Ref.: Docket 030-38417, License # 06-24000-01E
Mail Control No. 580556.
Subject Amendment to Exempt Distribution License 06-240000-01E

Smiths Detection Inc., with offices at 21 Commerce Drive, Danbury, Connecticut 06810, respectfully requests a license amendment for License No. 06-24000-01 E, to remove (Na-22) Sodium 22 Sealed Sources (Eckhart & Ziegler Isotopes Model HEG-XXX series) which will be replaced by the following Eckhart & Ziegler Sodium 22 sources (drawings are enclosed).

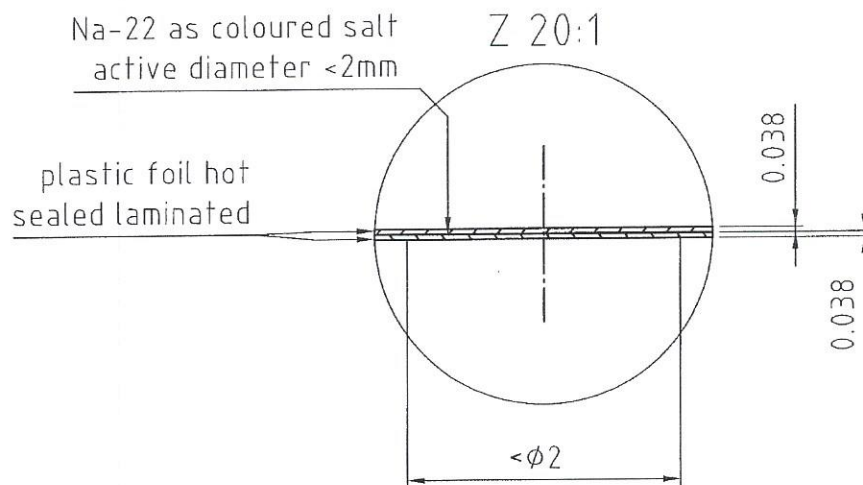
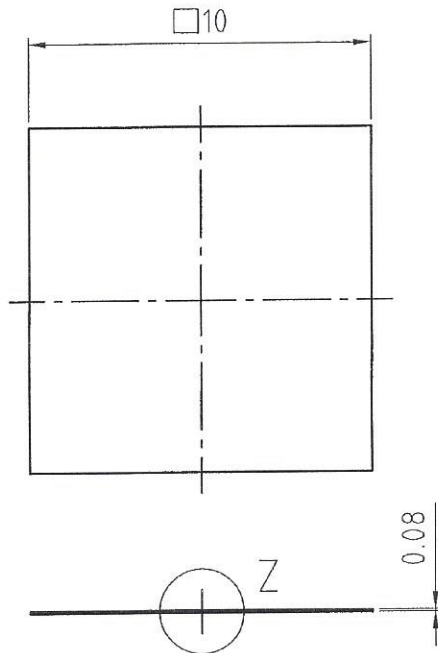
Source Model SKRB 17540: 200 Bq (0.005 microcuries) per drawing VZ-3549-004, Symetrica part # 410-0011

Source Model SKRB 18147: 600 Bq (0.016 microcuries) per drawing VZ-3549-004, Symetrica part # 410-0011.
